City of
Peterborough

COMMITTEE OF ADJUSTMENT
HEARING DATE: September 13, 2011

Staff Comments Re: Files: A29/11, A30/11, A31/11, B/11/11 & B12/11, A32/11, A33/11 and A34/11

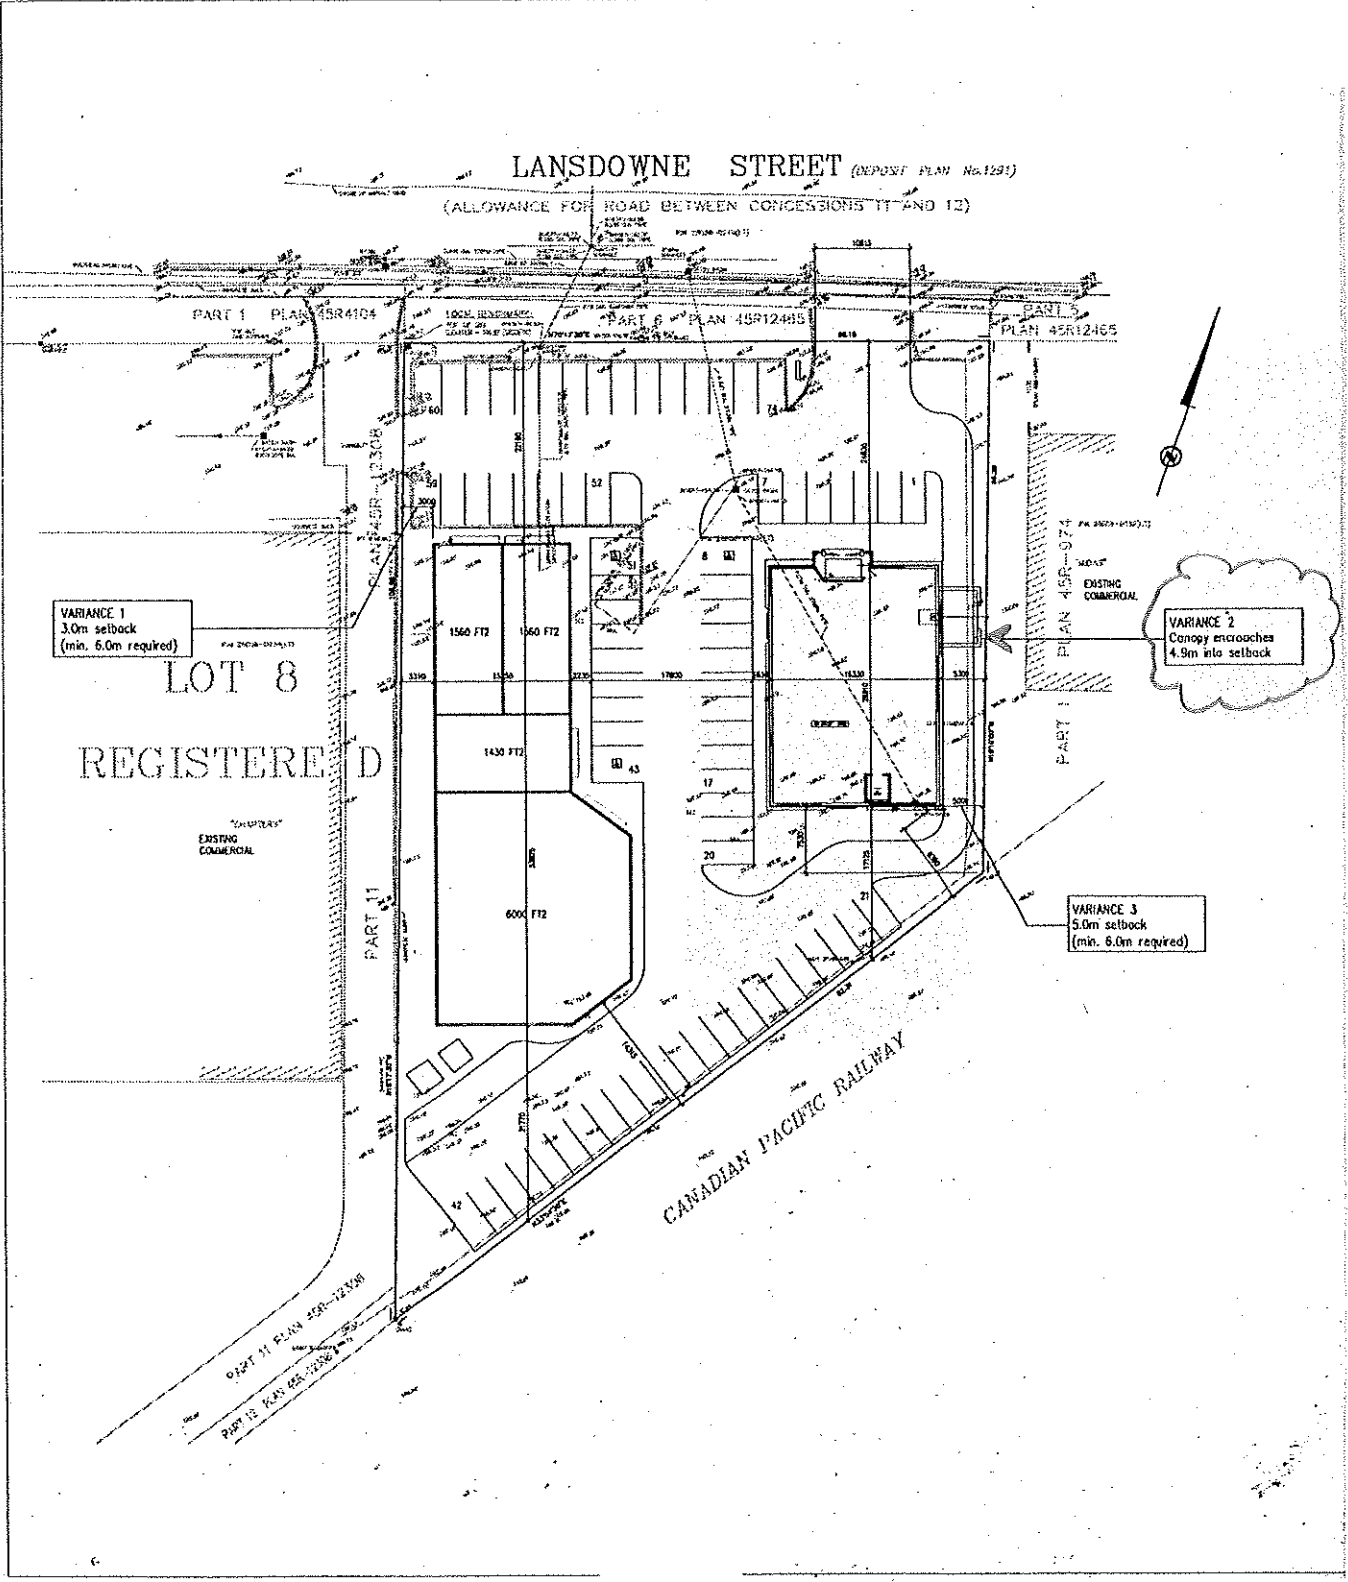
Because the additional sign area pertains to a proposed 2.134 square metre, freestanding sign associated with the clearance gate for the drive through located to the rear of the property, Staff is of the opinion that the added sign area will not contribute to the competition for sign exposure along the Chemong Road frontage. Considering the location of the sign in relation to the adjacent non-commercial property, Staff would not object to the variance requested considering the impact to be minor provided that the sign is not illuminated or does not have lights shining on it.

1 Site Plan School - New
1 250

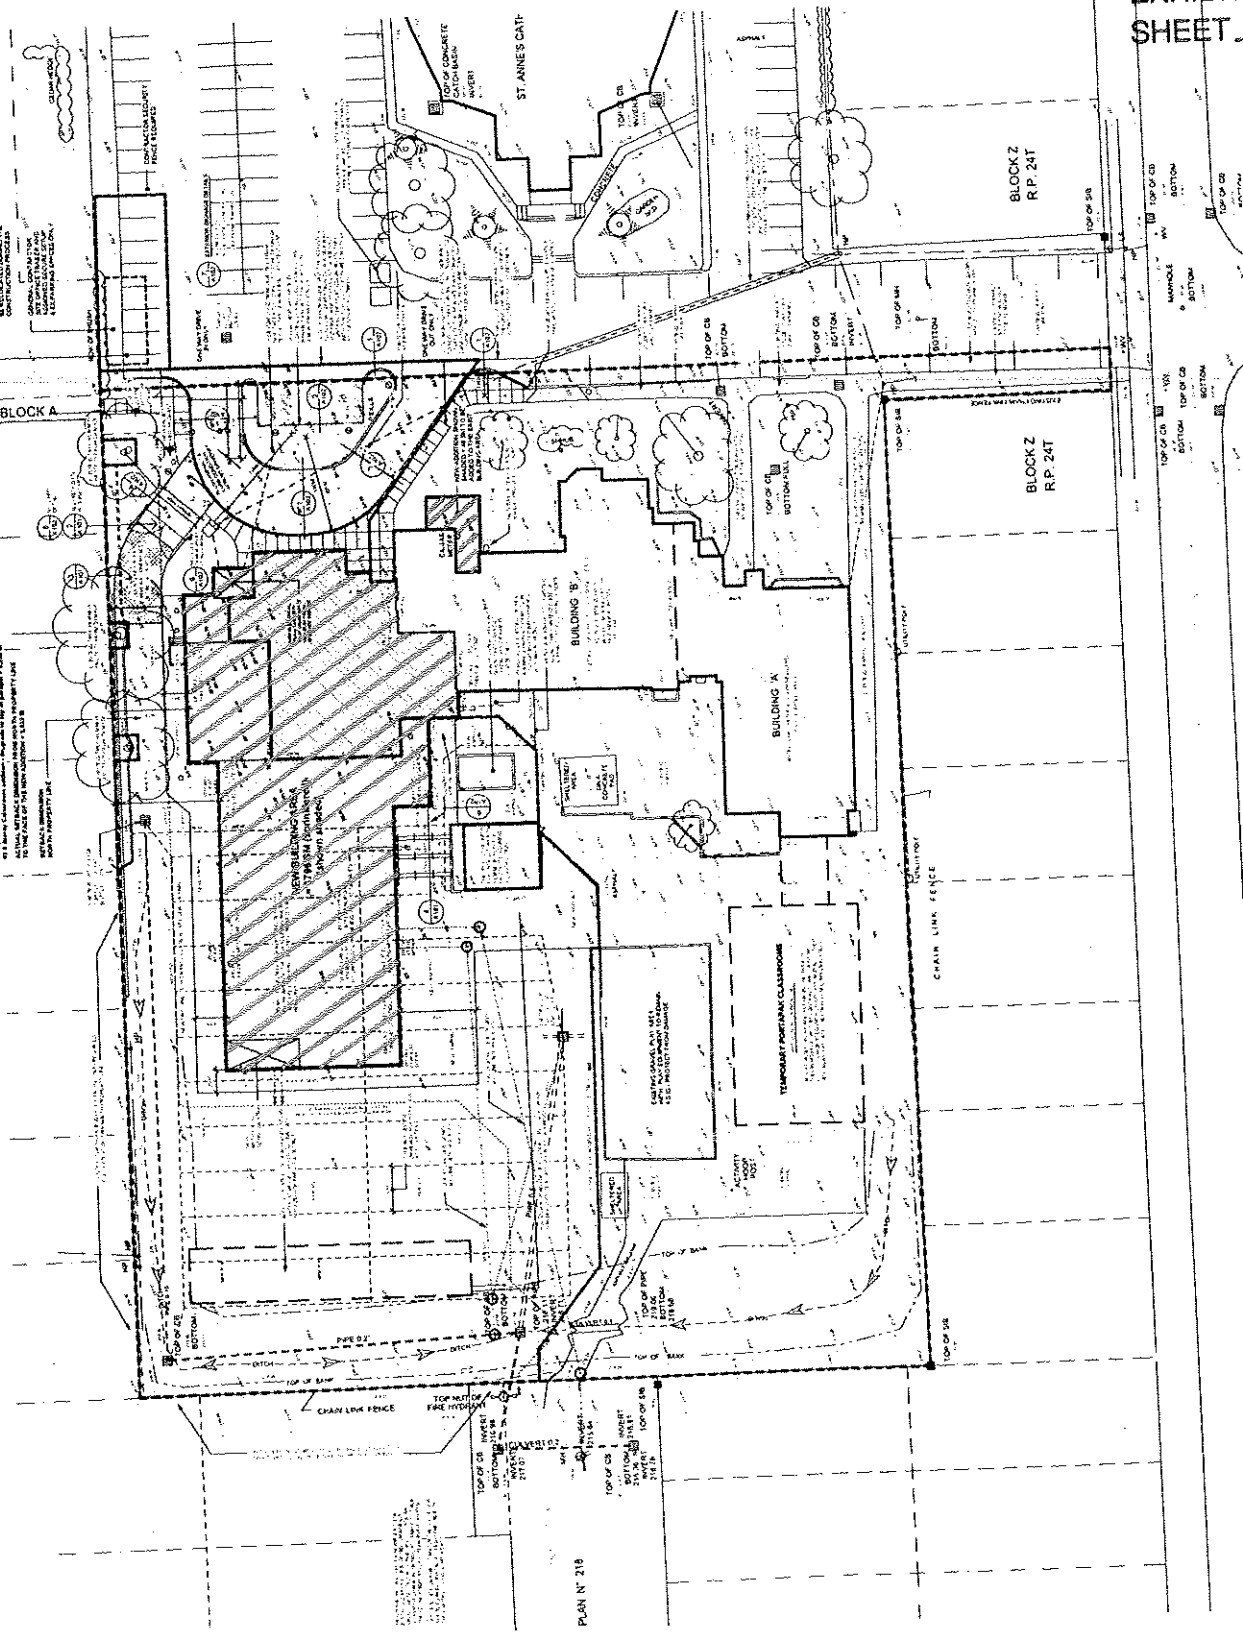
Referring to the Plan attached as Exhibit C, the property upon which the school is located is situated to the rear of residential properties with access through the adjacent church property from Barnardo Avenue and egress over the church property to Bellevue Street. The proposed addition consists of a gymnasium and 5 classrooms. While the gymnasium constitutes a substantial building addition that could function as a place of assembly, the by-law considers it as a classroom being expanded and therefore only requires parking associated with the additional classrooms.

The Church has an assembly area of 375 square metres and would therefore require 94 parking spaces to be provided on the property. The plan illustrates that there are 107 parking spaces provided on the church property. With the addition, the school will have 27 class rooms including the gymnasium that would be required to provide 54 parking spaces. The school would be required to provide 10 new parking spaces to support the 5 new classrooms.

The site plan illustrates that 4 new parking spaces are to be provided on the school property with a residual (107- 54=53) fifty three parking spaces available on the church property to accommodate the 6 more required by the school. It may also be considered that there is a residual (107-94 = 13) thirteen parking spaces on the church property to accommodate the 6 spaces required by the addition to the school, if the church was in session.

While the development of the property with absence of road frontage and parking for each property would not be permitted today, staff is of the opinion that the circumstances although being intensified, progresses toward an improved condition based on an accepted relationship between the two properties. Subject to concerns raised by neighbouring property owners Staff would not object to the variance to reduce the parking required to 4 parking spaces on the school property provided that the two consents for the cross easements describing the vehicle movement area and parking arrangement between the school and the church property are approved. It should be noted that pursuant to approval of the variance and consents, the development of the two properties will be is subject to site plan approval.

DRAWING TITLE:
TRAILER PLAN
DRAWN BY: BML
SCALE: 1/250

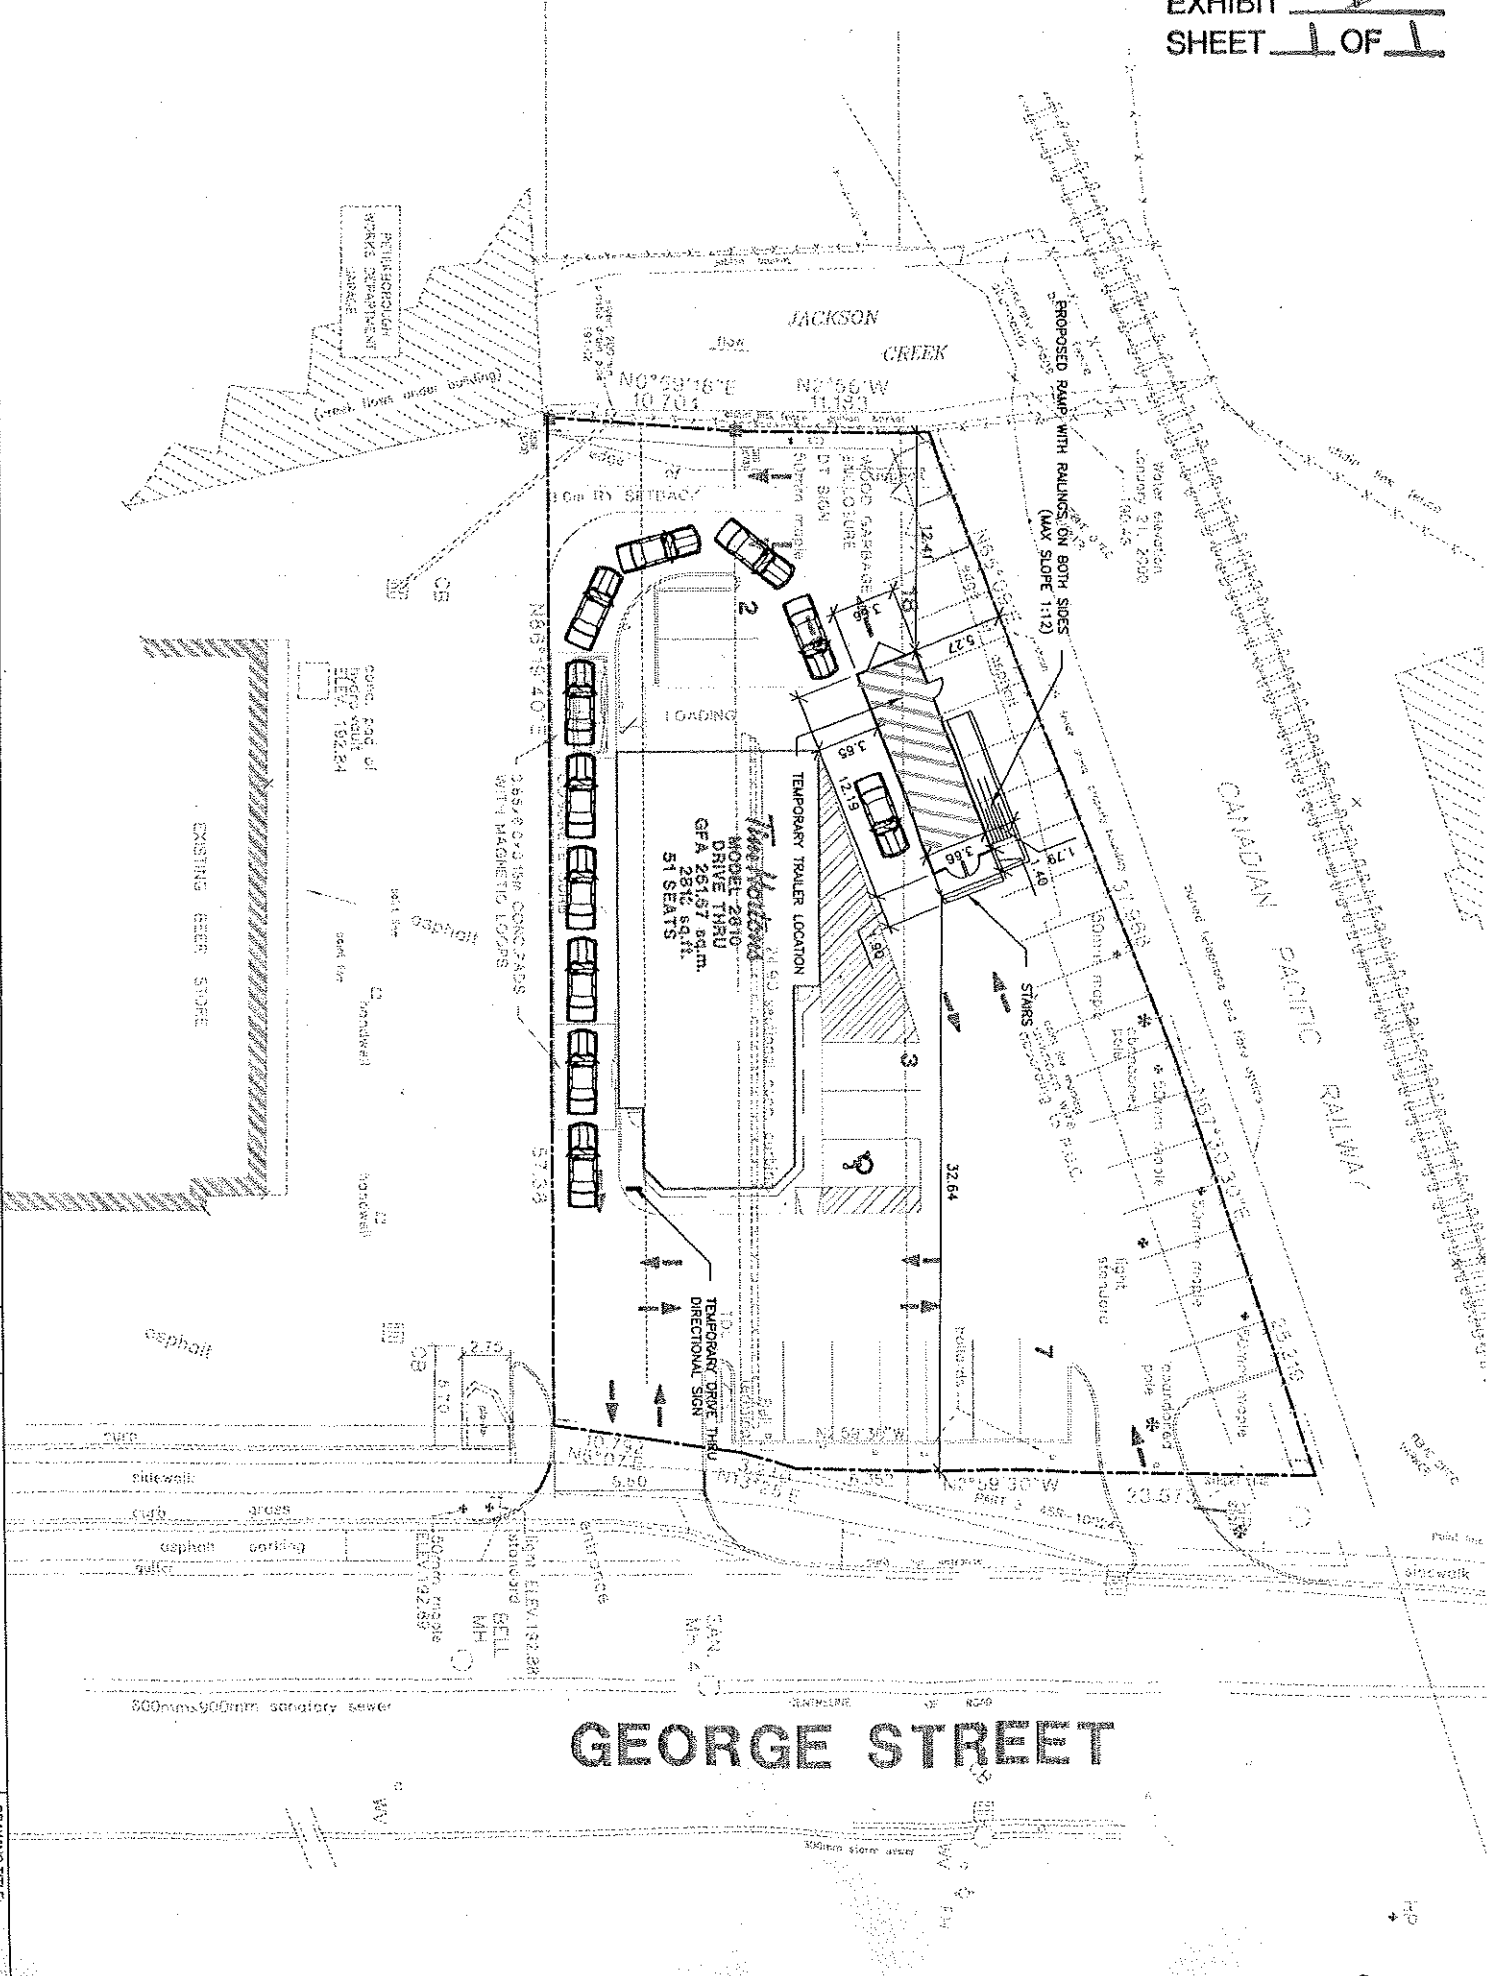
Referring to the plan attached as Exhibit D, staff is of the opinion that the trailer is located appropriately to allow the site to function adequately on an interim basis considering vehicle movement and parking as well as delivery and removal of refuse from the site.

Staff would not object to the Committee granting the variance as described for the temporary structure for a period of 5 weeks to commence upon issuance of a building permit within this year of 2011.
